Engine Control Module (ECM),
Reprogramming
Cummins ISL
GR

PI0884, Engine Control Module (ECM), Reprogramming

(July 2018)

W7086759

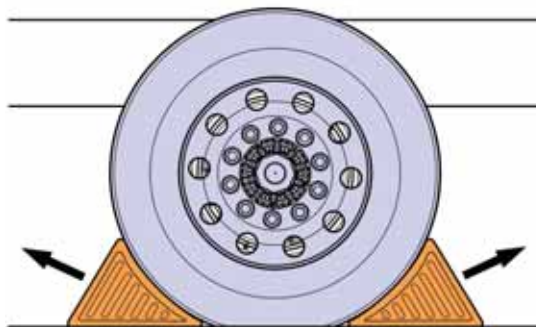
- 7 Select these parameters and change them to the settings in the table below.

New Parameter Settings	
Steps	Settings
a	Go to the Fan Control sections
b	Set the Air Conditioning Pressure Switch Input to “Enable”
c	Set Minimum Fan On Time for Air Conditioning Pressure Switch to “60”
d	Then Go to the SAE J1939 Multiplexing Section
e	Set Air Conditioning Pressure Switch to “Enable”
f	Set Source address to “17”

- 8 Save programmable parameters to the ECM.
 9 Ensure all Cooling Fan and A/C functions work correctly after the parameters are changed.
 10 Clear all Diagnostic Trouble Codes (DTCs) and disconnect from **INSITE**.
 11 Remove the wheel chocks.
